## Multi-signatory public comment response

Re: Project File #608020 Cape Cod Bridges Project

The Draft Environmental Impact Report Section 4.3.2 illustrates and describes the Bourne South Quadrant's shared use facility, summarized as follows:

Figure 2 - Location of proposed overpass versus existing path plan

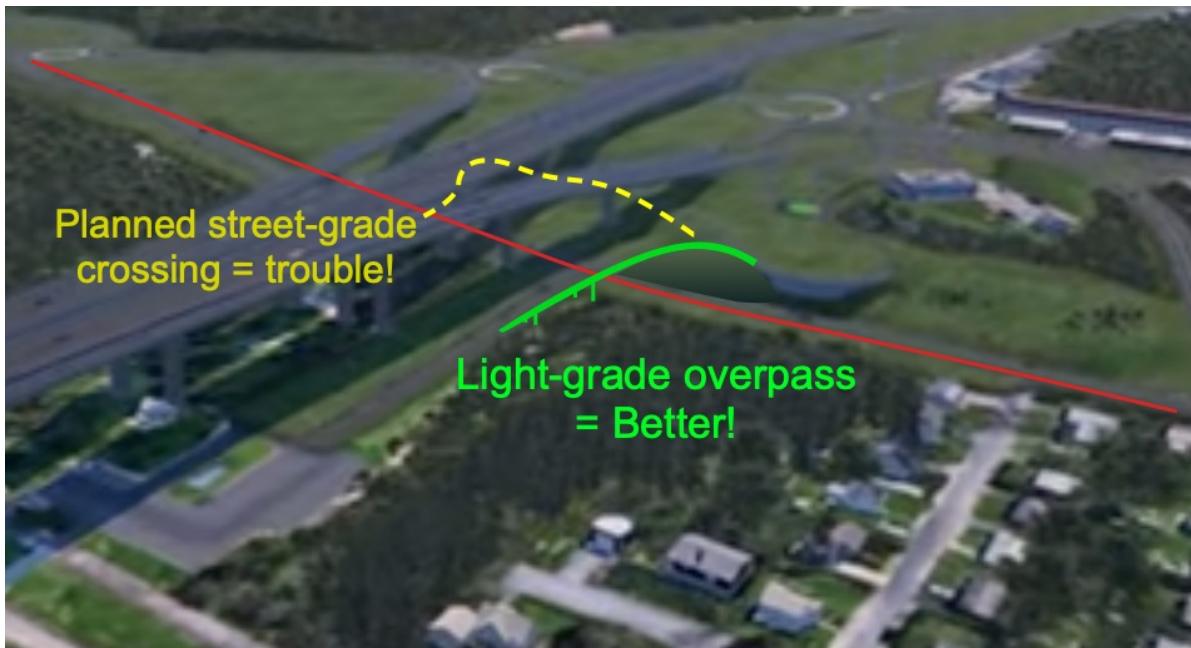
There is a simple, cost-effective alternative. Rather than constructing the path's long descent to road grade, the design could leverage the existing elevation and the now-planned retaining wall to create a light, ramped, grade-separated multimodal overpass, **eliminating the issue entirely**. Figure 2 illustrates this.

Figure 3 - Descent Ramp into existing public property

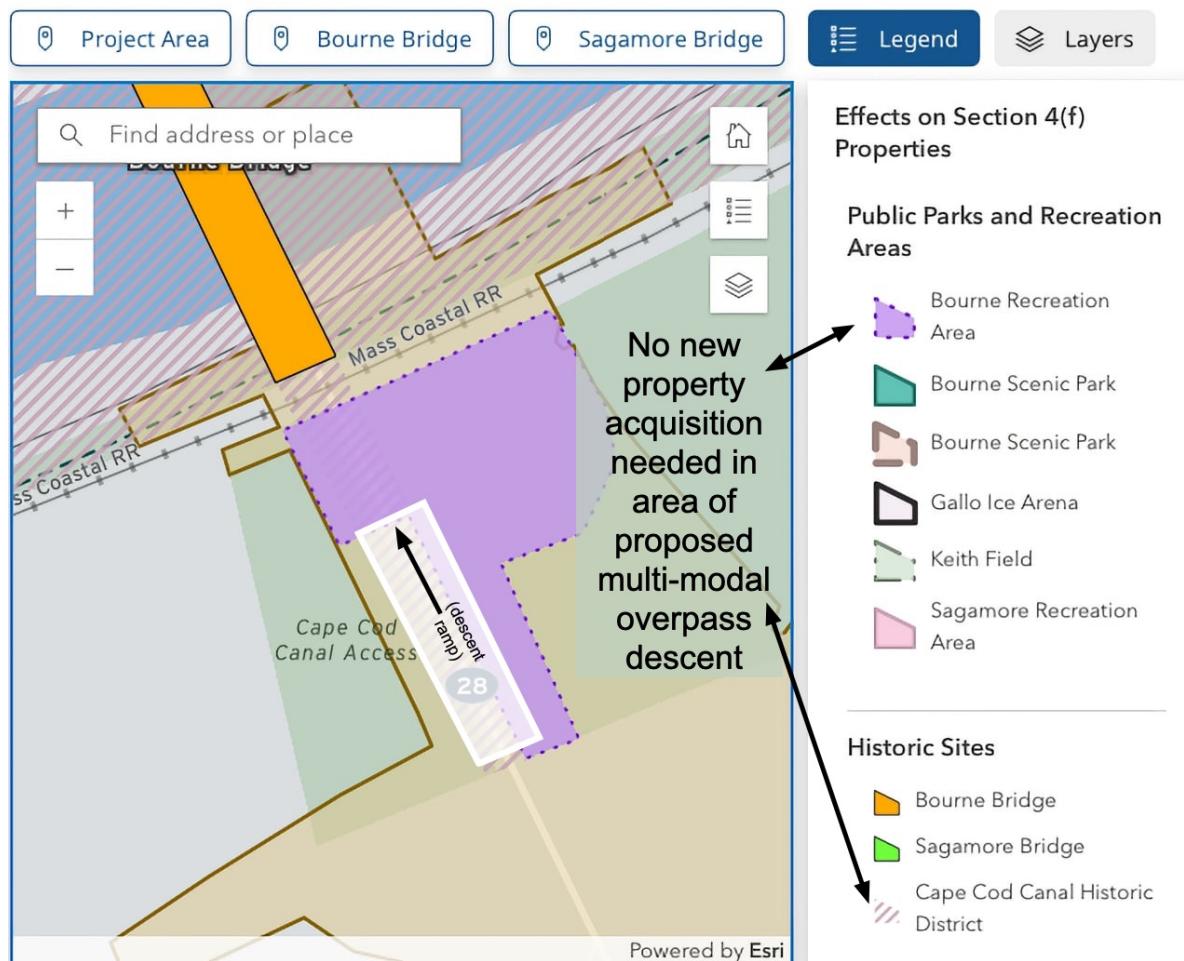
**No new property required.** The northern side of the overpass, which constitutes the descent over grade, can descend into the existing Bourne Recreation Area and adjoining Cape Cod Canal District property; no property taking is required. See rough placement illustrated in Figure 3.
